**Revision to a Request for Supply
Arrangement - Révision à une demande
pour un arrangement en matière
d'approvisionnement**

Title - Sujet Furniture for Work Spaces	
Solicitation No. - N° de l'invitation E60PQ-140003/A	Date 2015-05-14
Client Reference No. - N° de référence du client E60PQ-140003	Amendment No. - N° modif. 011
File No. - N° de dossier pq416.E60PQ-140003	CCC No./N° CCC - FMS No./N° VME
GETS Reference No. - N° de référence de SEAG PW-\$\$PQ-416-66821	
Date of Original Request for Supply Arrangement 2015-02-19 Date de demande pour un arrangement en matière d'app. originale	
Solicitation Closes - L'invitation prend fin at - à 02:00 PM on - le 2015-05-28	
Address Enquiries to: - Adresser toutes questions à: Clouthier, Chantal	Buyer Id - Id de l'acheteur pq416
Telephone No. - N° de téléphone (819) 956-7184 ()	FAX No. - N° de FAX () -
Delivery Required - Livraison exigée	
Destination - of Goods, Services, and Construction: Destination - des biens, services et construction:	
Security - Sécurité This revision does not change the security requirements of the solicitation. Cette révision ne change pas les besoins en matière de sécurité de l'invitation.

This amendment 011 is r

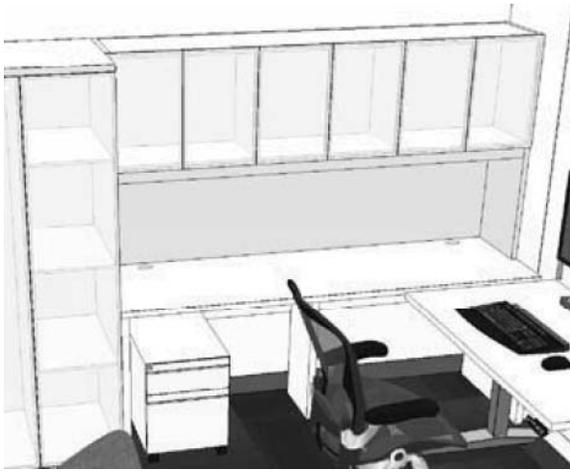
Category 1b requests wardrobes 15”d, 18”d, 20”d and 24”d – Annex A-1, #7.9.1, 7.10.4, and 9.7.3, requires that these wardrobes have a coat rod. A standard hanger will not fit in a 15” or 18”d wardrobe (see attached picture). The industry has designed wardrobes with a coat hook if the depth does not allow for a standard hanger. Please revise Annex A-1 to allow for coat hooks for 15” and 18”deep wardrobes.

Thank you for your explanation. Wardrobe 381 mm (15in.) and 457mm (18in.) deep will be deleted from Product Catalogue1.B. Modifications to the Product Catalogue will be posted shortly.

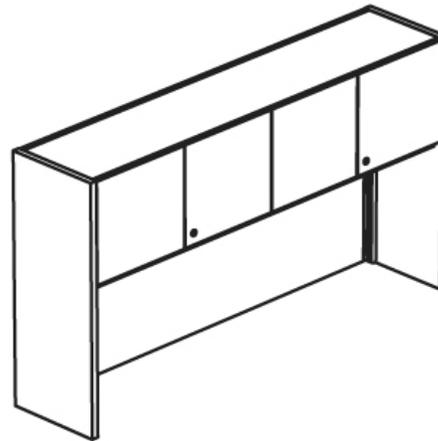
Category 1b includes Freestanding Laminate products which can be used in open environments as well as closed offices where Category 4 Wood Products are not required. However, there is no section in Category 1b to allow for a traditional closed office hutch style storage (see illustrations attached), which would be allow for high storage up to 66"high. (a) is from a recent PWGSC RFP. Please add hutch style storage up to 66"high to Category 1b.

A.177: No, the hutch style storage up to 66"high to Category 1b will not be added at this time..
